REPORT

FROM: Planning and Development Department

SUBJECT: Recommendation Report – Zoning By-law Amendment and Draft Plan of Subdivision, Argo Lions Valley, 1303 Dundas Street West, File No. Z.1323.01 and 24T-25002.1323

Figure 9 – Dual Frontage Townhouse Showcase prepared by Applicant

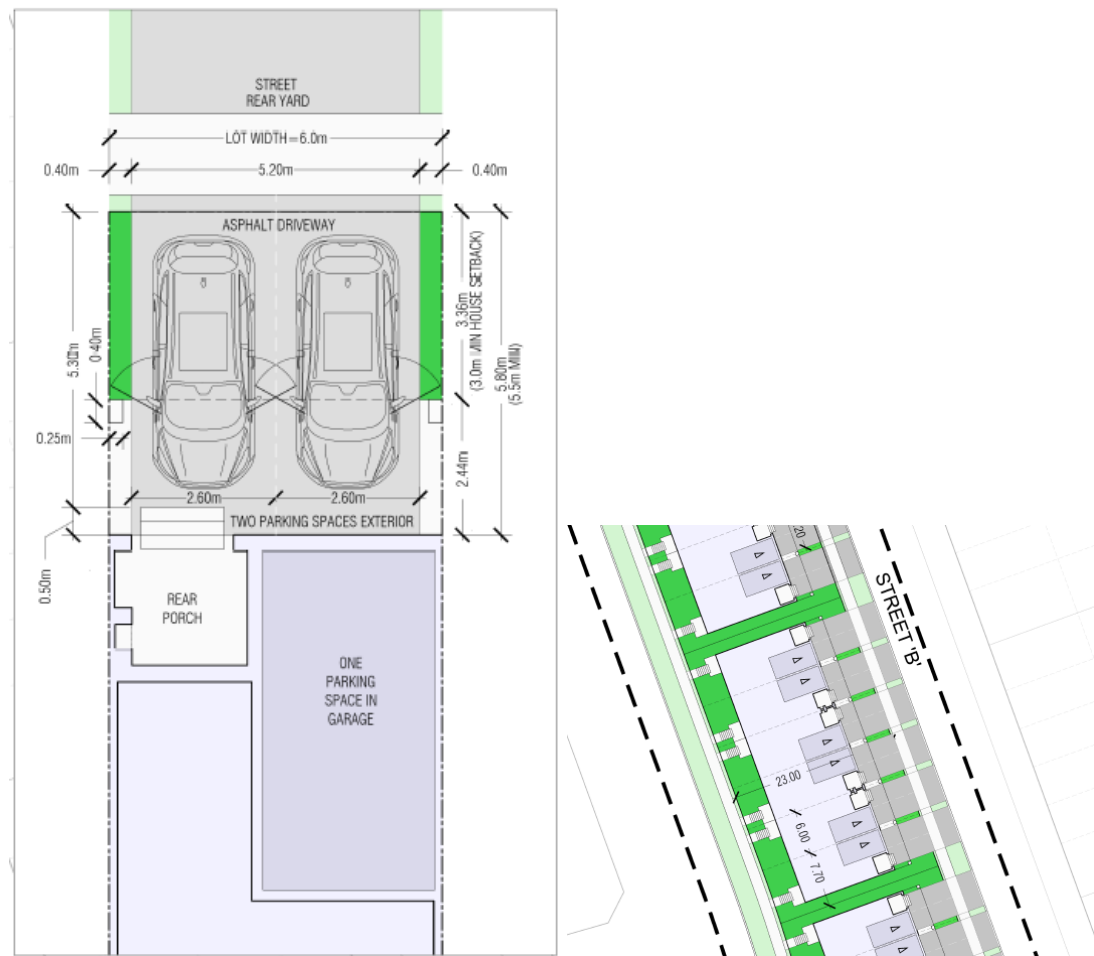
A key concern with the proposed widened driveways is the functionality of the parking and access to the unit. As shown on Figure 9, there is insufficient space between a parked vehicle, the steps and porch entrance. The parking space is also constrained by posts on either side of the driveway.

If two vehicles were parked in the widened driveway, the entrance to both units could be obstructed. More specifically, a parking space is required to be a minimum of 5.2 m in length, and the garage is required to be setback a minimum of 5.5 m from the property line. Figure 9 shows a setback of up to 5.8 m may be provided. This means that between 0.3 and 0.6 m would be provided between the parking space and the porch. Figure 9 further shows that steps, where required due to grading of the lot, could extend toward the required parking space resulting in a 100 mm (4 inches) distance between the step and the parking space which further reduces accessibility.

This foregoing also appears to contravene the *Ontario Building Code* as the Code requires clearance between the lowest step and a parked car to be at least 860 mm. As shown in Figure 9, the clearance with steps is 100 mm (4 inches). In staff's opinion, this is insufficient.

The applicant provided staff with rationale for the widened driveways, and while this information was appreciated, staff evaluated the submissions and do not recommend approval for the following reasons.

While the ARUs could provide increased and additional housing options on balance staff are not recommending approval of the widened driveway request for the above reasons. Should ARUs with side-by-side parking be desired, they could be accommodated within the proposed plan of subdivision in the detached dwellings with double driveways permitted as-of-right.

Figure 10 – Parking Plan Excerpts

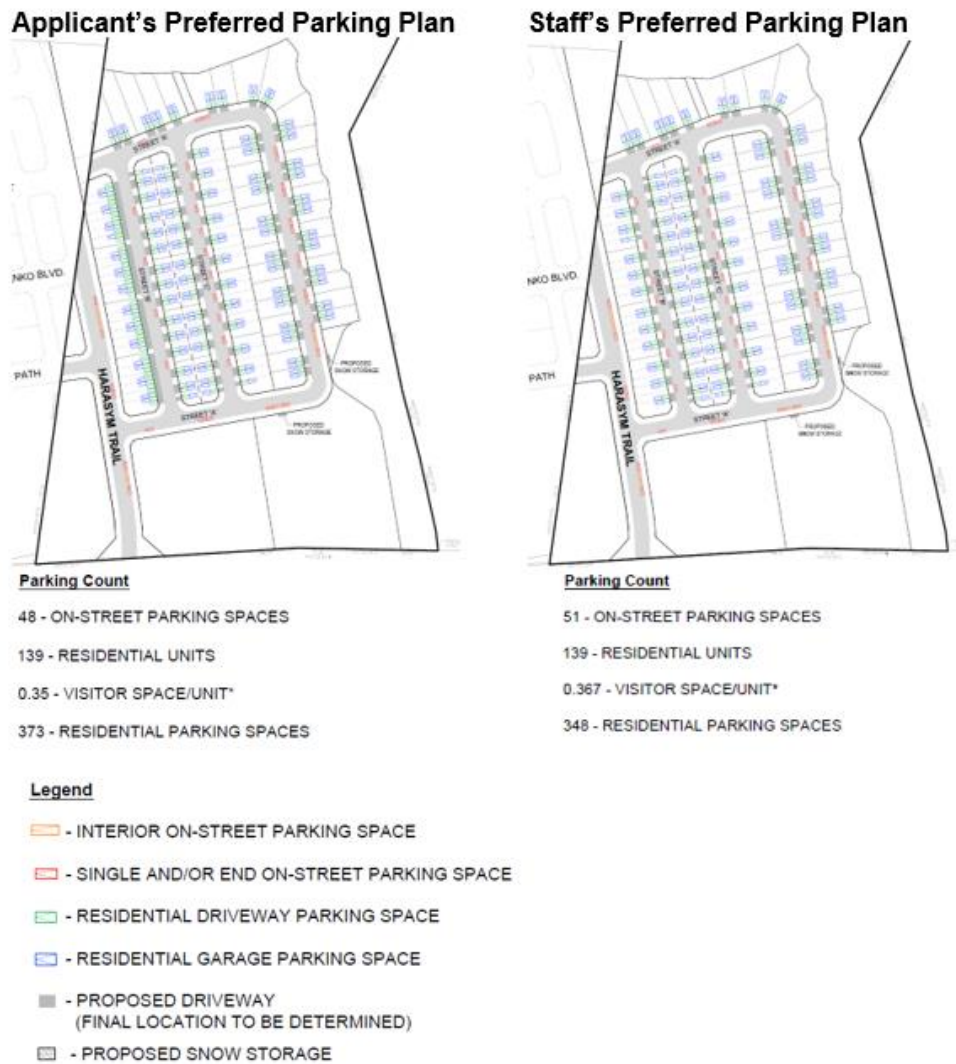
The applicant has prepared two parking plans to demonstrate the differences in available on and off-street parking between the proposed widened driveways and the single car By-law regulation (Figure 10 also attached in Appendix 'E'). The plans show the proposed widened driveways would provide 25 additional private parking spaces in driveways, and the By-law regulation would provide three additional public on-street parking spaces, a net difference of 22 parking spaces.
